Item Name: Replacement Skidtube, Low & High Gear with Standard Wearplates Fits LH or RH

DRAWING NO. D2650	TITLE 206/407 SKIDTUBE ASSEMBLIES	REV. F	DART AEROSPACE LTD ENGINEERING ORDER		D.E.O. NO. D2650-F-1	SHEET NO. SHEET 1 OF 1	SCALE NTS
DRAWN <i>JP</i>	CHECKED <i>A.P.</i>	MFG. APPR. <i>AA</i>	APPROVED <i>HH</i>		DE APPR. <i>HH</i>		
DATE 12.10.12	DATE 12.10.22	DATE 12.10.22	DATE 12.10.22		DATE 12.10.22

CHANGE C'BORED WELDED CROSSBOLT SPACERS TO SWAGED SPACERS

DETAIL G

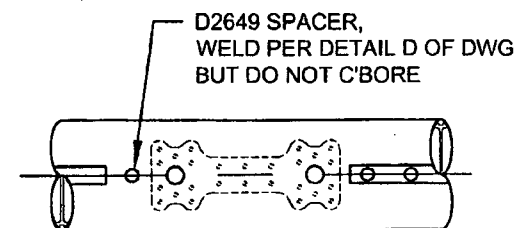
ADD DETAIL G BELOW, WHICH IS THE SAME SECTION VIEW AS DETAIL D OF DWG.
C'BORED HOLES ARE **NOW SWAGED** PER DETAIL G BELOW. FOR THE Ø0.375 HOLE THAT IS NOT C'BORED, WELD PER DETAIL D OF DWG (SEE AMENDED DETAIL B FOR REFERENCE).
